Project	IEEE 802.16 Broadband Wireless Access Working Group < http://ieee802.org/16 >	
Title	Proposal on DLFP Format Change for 802.16 OFDM	
Date Submitted	2003-12-29	
Source(s)	Vladimir Yanover, Naftali Chayat, Tal Kaitz (Alvarion Ltd.) Martin Lysejko (Airspan) 21 A Habarzel St. Ramat - Hahayal Tel - Aviv 69710	Voice: +972-36457834 Fax: +972-36456222 mailto:vladimir.yanover@alvarion.com mailto:naftali.chayat@alvarion.com mailto:tal.kaitz@alvarion.com
Re:	Supporting document for Letter Ballot #13a	
Abstract	The document suggests DLFP Format Change for 802.16 OFDM. Such change allows to fix problem of DL-MAP overhead (that also decreases penalties of certain STC solution), to eliminate special case when MAC PDU is crossing boundary between two PHY bursts and to relax real time problems in DL-MAP parsing	
Purpose	The document is intended for consideration within comments resolution process	
Notice	This document has been prepared to assist IEEE 802.16. It is offered as a basis for discussion and is not binding on the contributing individual(s) or organization(s). The material in this document is subject to change in form and content after further study. The contributor(s) reserve(s) t

3. DLFP and Regular DL-MAP

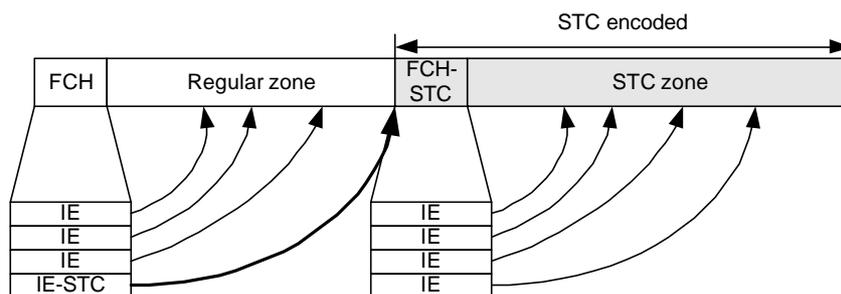
DL-MAP message will still be used, but it will not cross the boundary between FCH and burst #1. Format of DL-MAP is not changed. Bursts specified by DLFP will not be specified in DL-MAP and opposite.

In most cases there will not be more than 5 bursts in the DL, then the only information left to DL-MAP is PHY Sync information (particularly frame number), BS ID etc.
